Exhibit A2 - Floor Plan Modifications

First Floor Plan

Strawberry
Ranch

Strawberry Ranch
Lot 15 Cottonwood Meadow
Sanford, ME

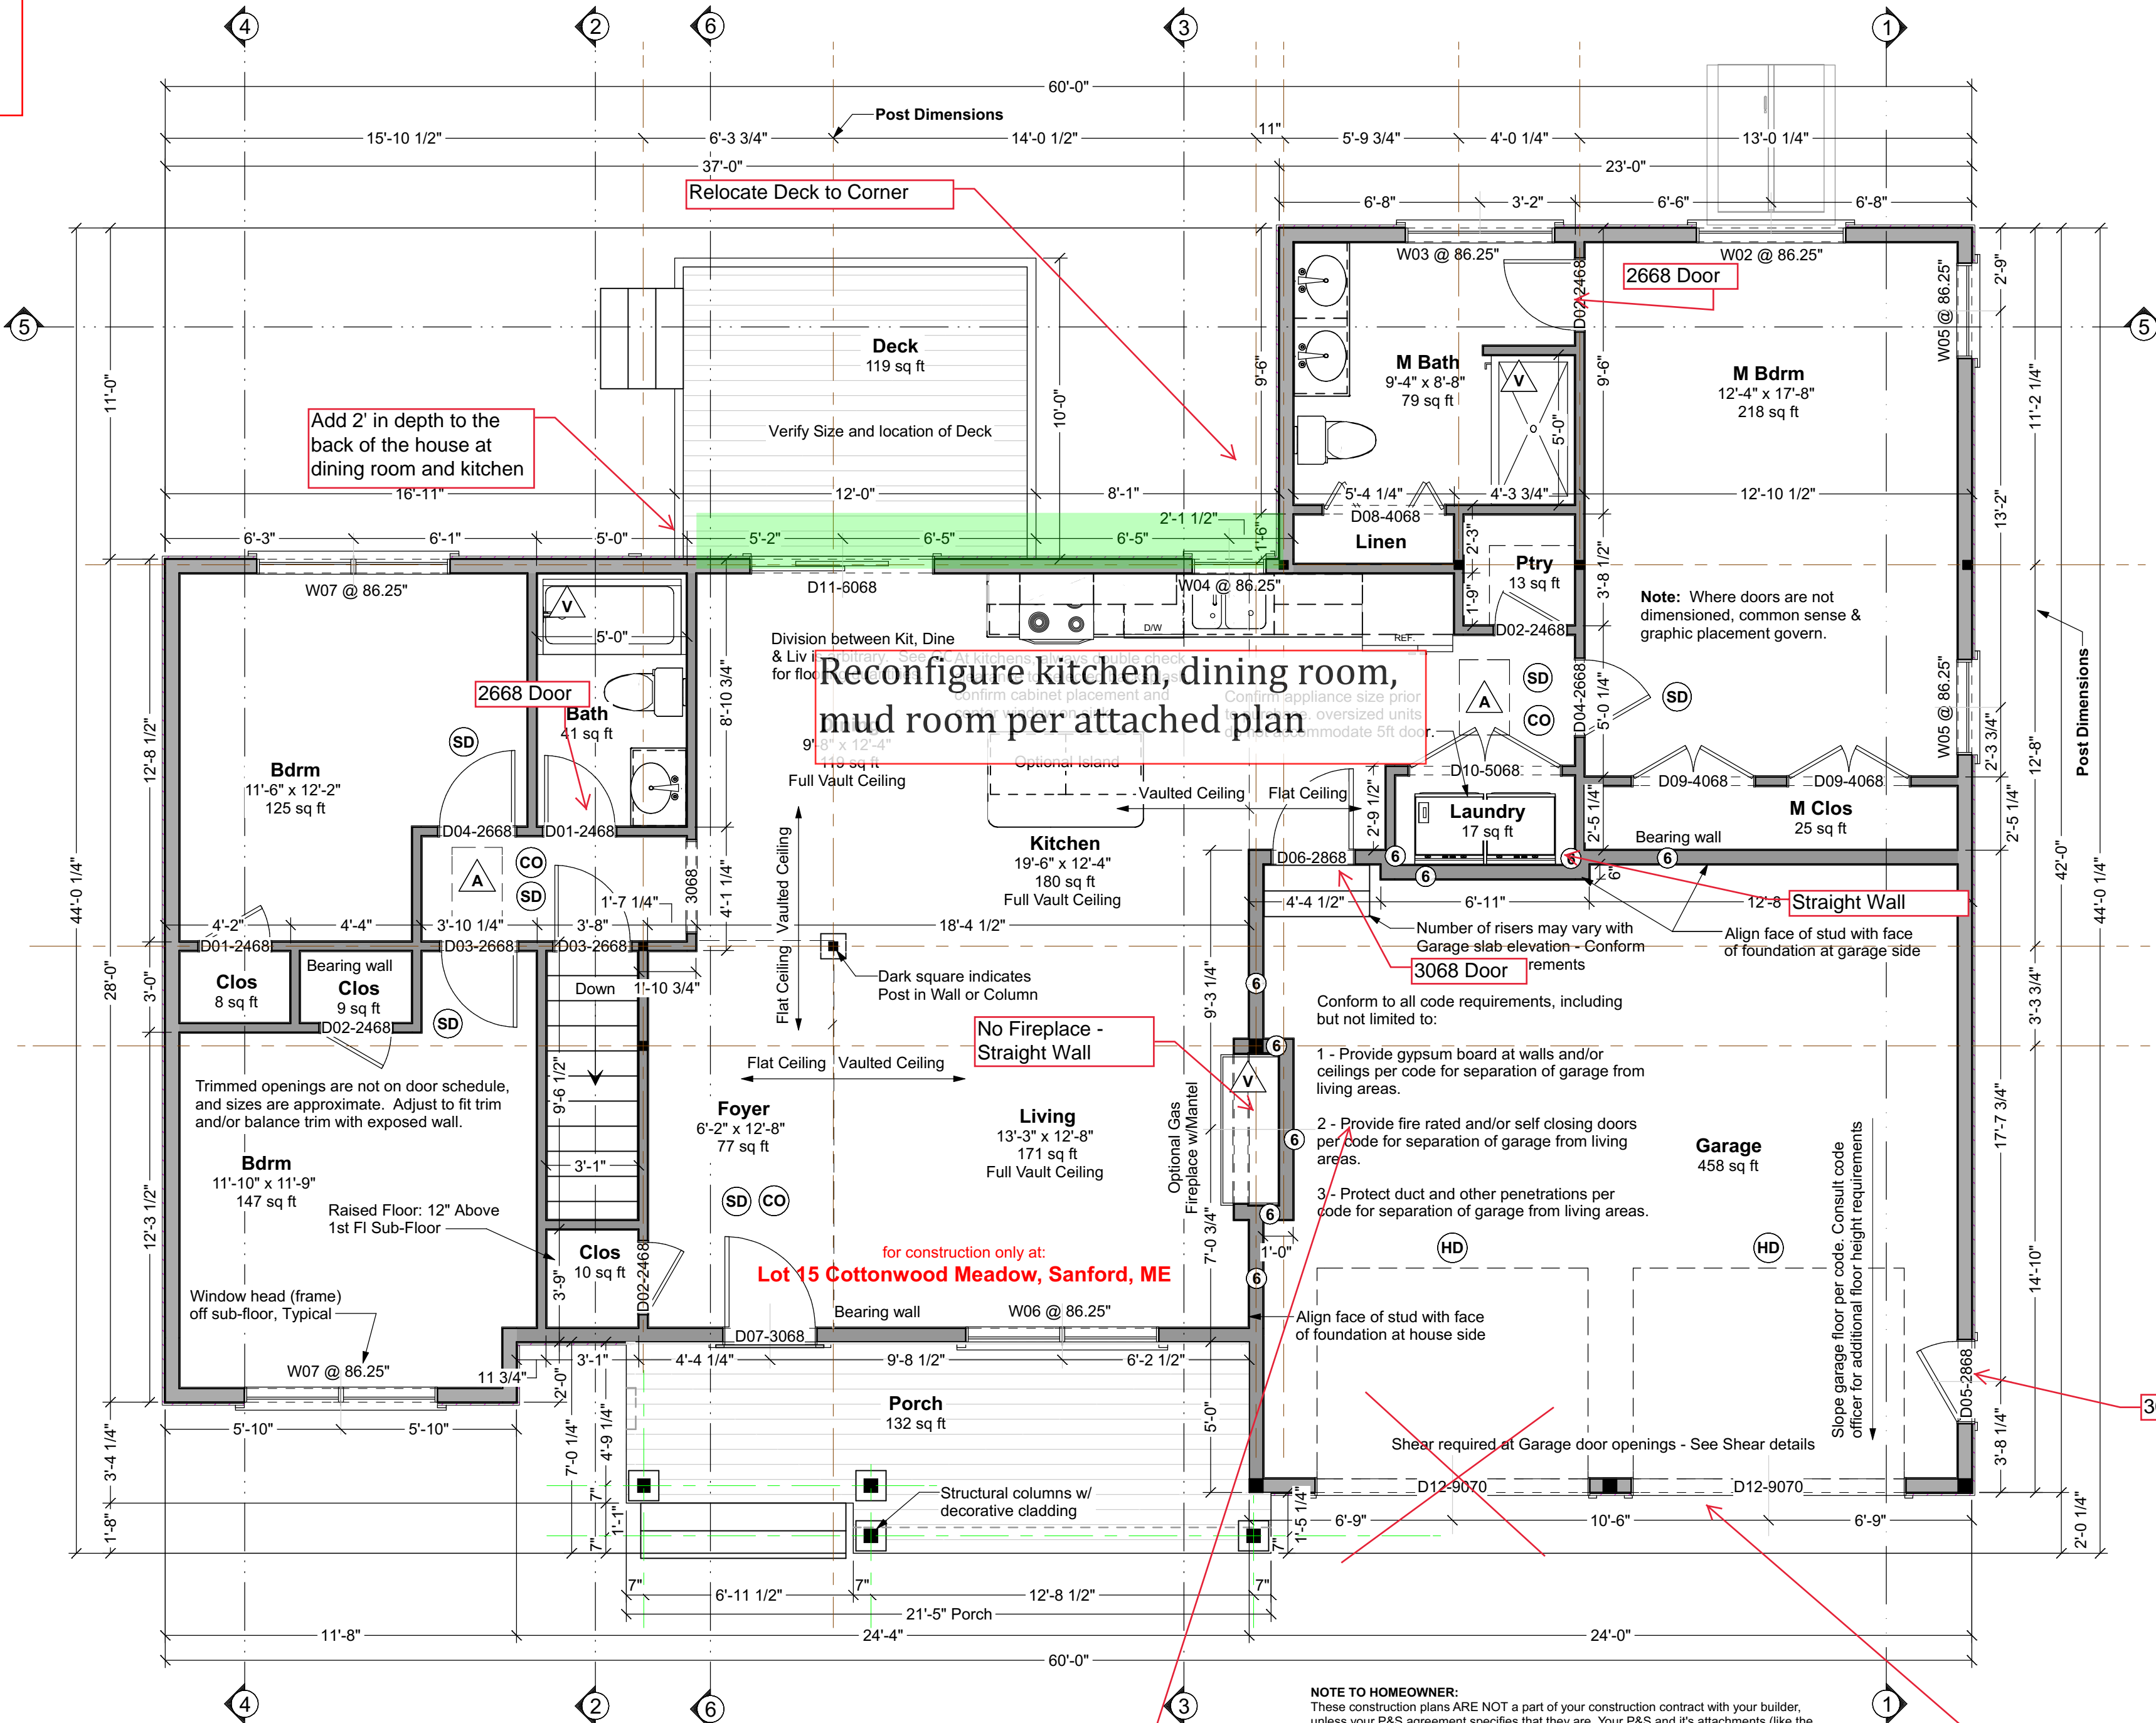
Is it possible for you to draw in a wheelchair ramp?
